RE: Central Park South

I reviewed the revised drawings that have been submitted with the formal planning application. My comments and recommendations are summarized below.

SITE PLAN

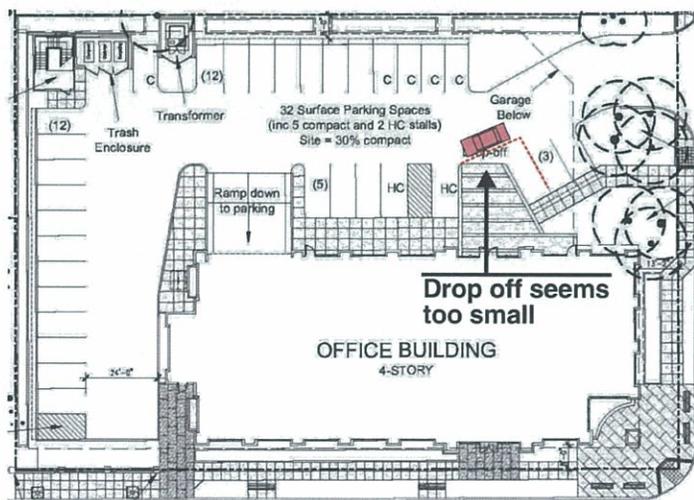
There were two items that were not addressed in the formal application drawings. I believe they are important, and still recommend that staff discuss them further with the applicant. They are as follows:

1. The drop-off area at the east side of the office building, being shorter than the length of a car, seems too small. Larger cars parked adjacent to the drop off might overhang the space at the drive aisle. This could make it difficult for a passenger to be dropped off near the curb.

2. The view at the residential auto forecourt and garage entry is not the best as it focuses on the ramp to the garage.

Recommendation: Consider increasing the length of the drop-off area by eliminating one parking space.

Recommendation: See the recommendation in the residential comments section below for this condition.

RESIDENTIAL BUILDING

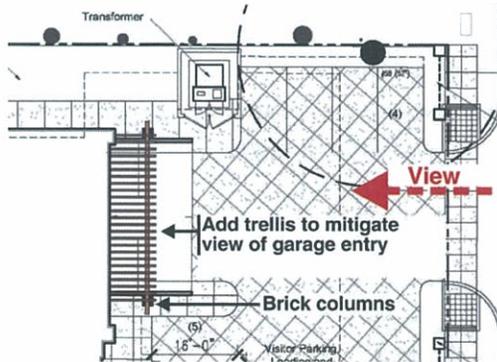
1. The view at the entry to the auto forecourt and the garage, mentioned in the site plan comments above, is important. Almost everyone will enter the project via the driveway at the east end of the parcel frontage - either to access the garage or to drop off a passenger at the building entry on the right side of the car. This view currently focuses on the garage entry.

Recommendation: Design an element to mitigate this view. A landscaped trellis feature supported on brick columns to match the building base is shown on the plan and elevation illustrations above and below. See the photo to the right of a similar condition at a multifamily building on Laurel Avenue.

Refine balcony railings design
(See examples)

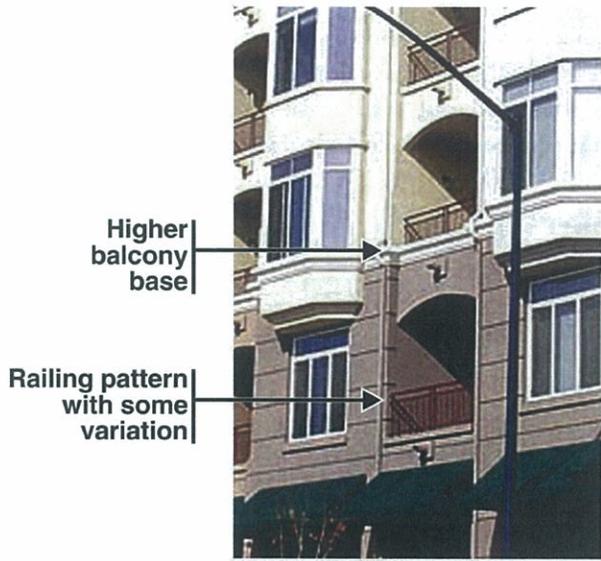
2. The Planning Commission in its October study session raised a concern that the balconies seemed too ordinary, and that one might be seeing residents' possessions stored on the balconies.

Recommendation: Refine the balconies to incorporate more interesting metal railings. Also consider decreasing the amount of open railing at the bottom of the balcony fronts to provide more visual screening of items placed on the balconies. There are numerous design solutions. A few examples are shown on the following page.

Currently Proposed Office Building Design (El Camino Real side)

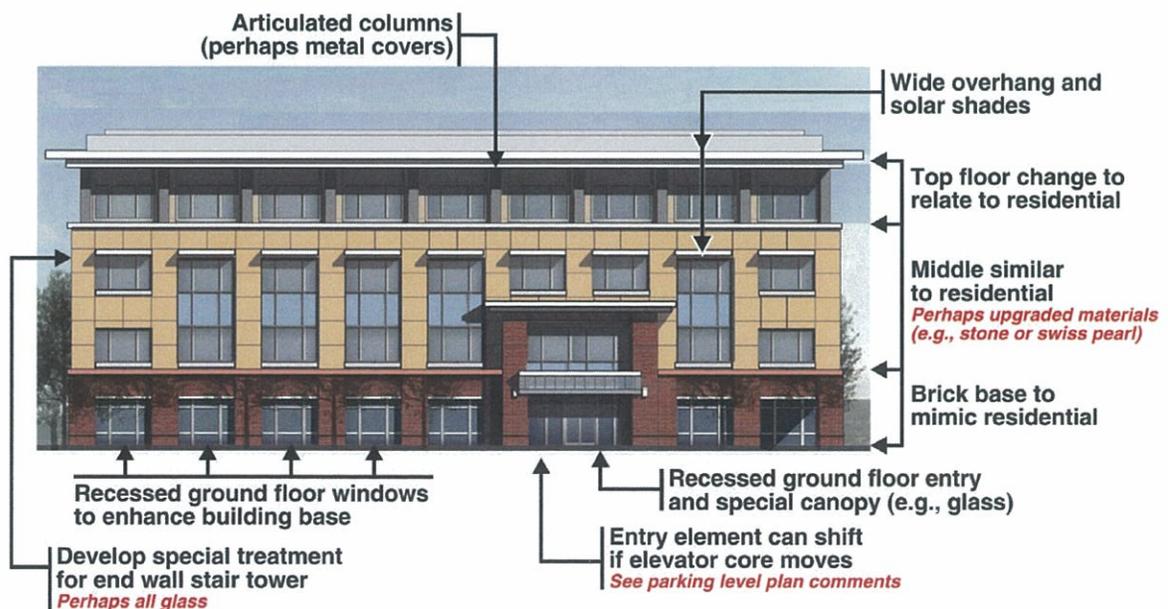
The Planning Commission asked at their October study session for substantial additional design study of the office building. Specific concerns were identified in my March letter. Many of those have been addressed. However, the exterior design seems quite heavy, and not well suited to its location adjacent to Central park where it will serve as a significant entry landmark for Downtown San Mateo. The evolution of the office building is shown in the comparison of the El Camino Real facade designs below.

Top portion of structure is very heavy

El Camino Real Elevation Recommendations

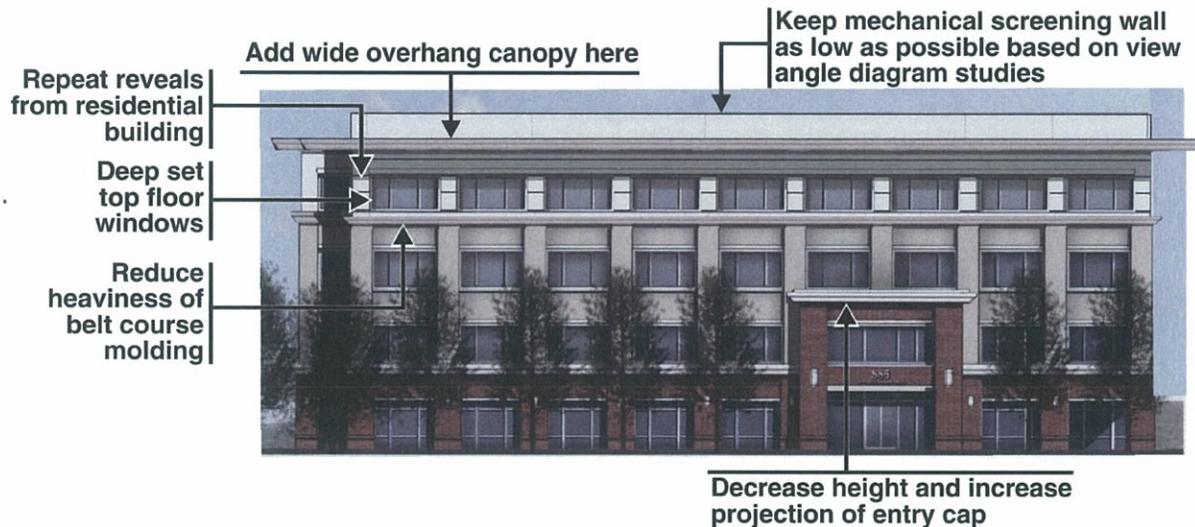
The applicant has strongly expressed a desire to use the facade design pattern and materials from the original conceptual design reviewed by the Planning Commission. While I generally believe that the character of El Camino Real and the Downtown Area would benefit from a fresher design approach, I looked at the proposed design, and have offered only some modest recommendations for changes to reduce the visual bulkiness of the building. These are shown on the illustration below.

One additional desirable design change, not shown on the illustration, which I would encourage is the addition of a well designed entry canopy for both the El Camino Real and parking lot entries. One example is shown in the photo to the right.
